Docket Item #1  
BAR CASE # 2011-0212

BAR Meeting  
September 7, 2011

**ISSUE:** Signage  
**APPLICANT:** T.J. Stones  
**LOCATION:** 608 Montgomery Street  
**ZONE:** CDX / Commercial Downtown Zone

Figure 3: Proposed Wall Mounted Letters

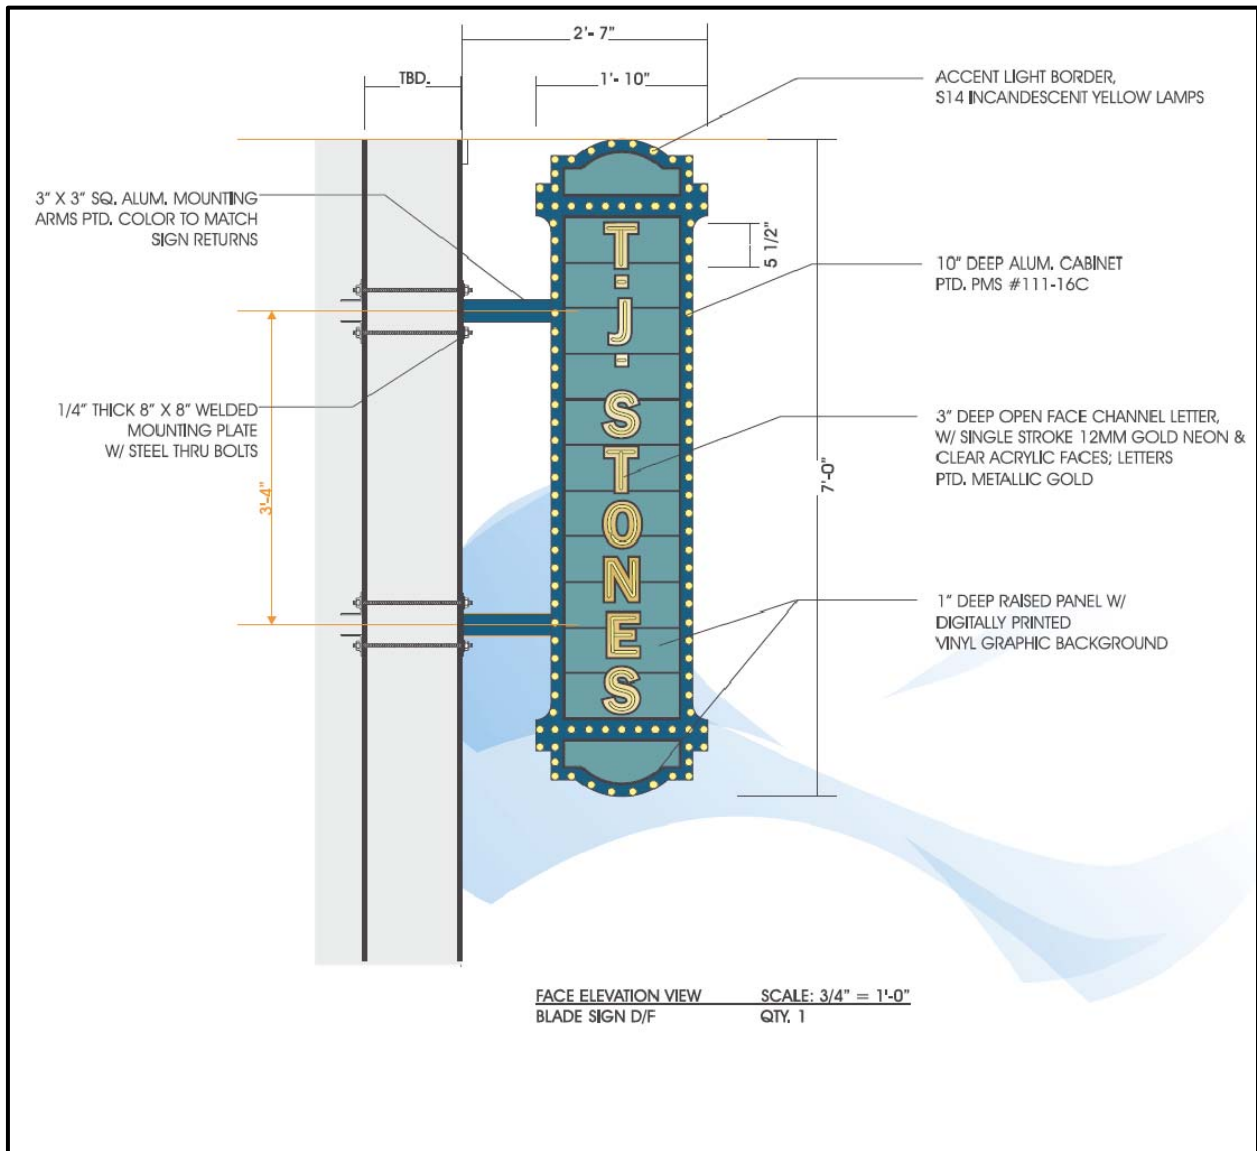
Staff feels that the proposed signs are appropriate for a mid-20<sup>th</sup> century building. The design of the signs and use of historically appropriate materials relate to the architecture and do not hide or obscure its significant features. The proposed location of the blade sign between the two, existing storefronts complements the existing architectural style of the building. To ensure that the blade sign is consistent with the BAR and zoning requirements, Staff recommends that the Board require that the sign's illumination be fixed and not flash or run around the perimeter of the sign as chaser lights. Additionally, the metal halo-illuminated letters to be installed in the brick panel insets above the storefront bays should be reduced in height from 16" to 14" to avoid visual conflict with the 16" interior height of the existing brick inset.

1. That the two sets of halo-illuminated, reverse-channel wall mounted letters affixed to the existing brick panel insets above the storefront bays will not exceed 14” in height.
2. That the blade sign’s illumination is not animated and does not flash or run around the perimeter of the sign.
3. That the illumination levels of all signage will be reviewed and approved by BAR staff in field upon completion.

Figure 4: Proposed Blade Sign

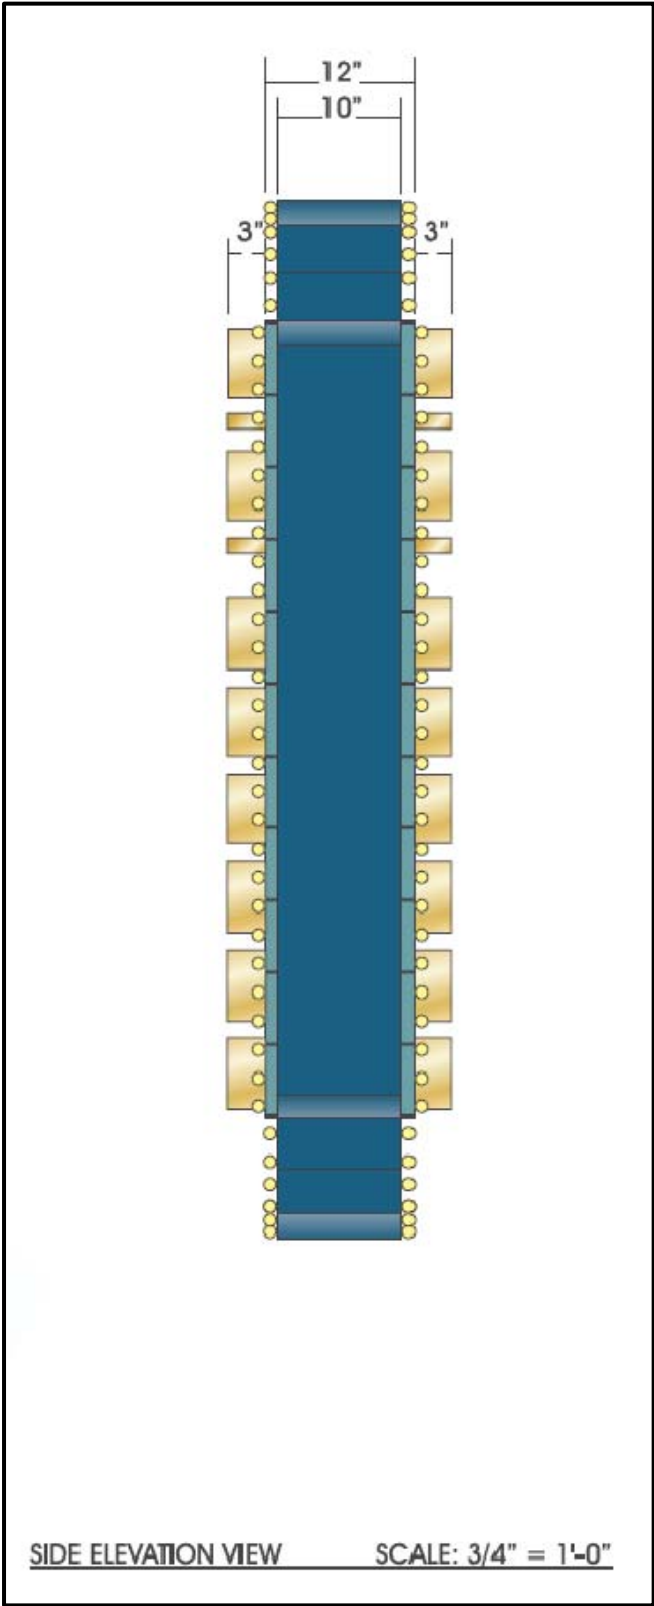
We have reviewed the project, and we do have concerns regarding the proposed lighted sign that will be placed perpendicular to the building. While the style of the sign is appropriate to the mid-twentieth century time period when this section of Alexandria was developed, we feel that the stylized sign is not keeping with the "dignity, purpose and memorial character" of Washington Street, just a half block away.

We have long advocated for muted lighting on Washington Street and minimal advertising. The neon and LED sign proposed here will be visible from Washington Street, especially at night. BAR staff has informed us that the sign will not be animated, contains no "racing lights", and can be stepped down after a review period. We appreciate these facts. But we cannot ignore the fact that this submission represents the type of sign we would least like to see in the Washington Street corridor.

Our concerns with BAR 2011-0212 are tempered by the fact the proposed sign will be on a side street, but we do not want to set precedent. The BAR has done an excellent job of viewing each submission before the BAR as a singular action, while taking the context of the surrounding neighborhood and the memorial character of Washington Street into consideration. Should similar signs be proposed in the future, we hope the BAR will apply such scrutiny to those as well.
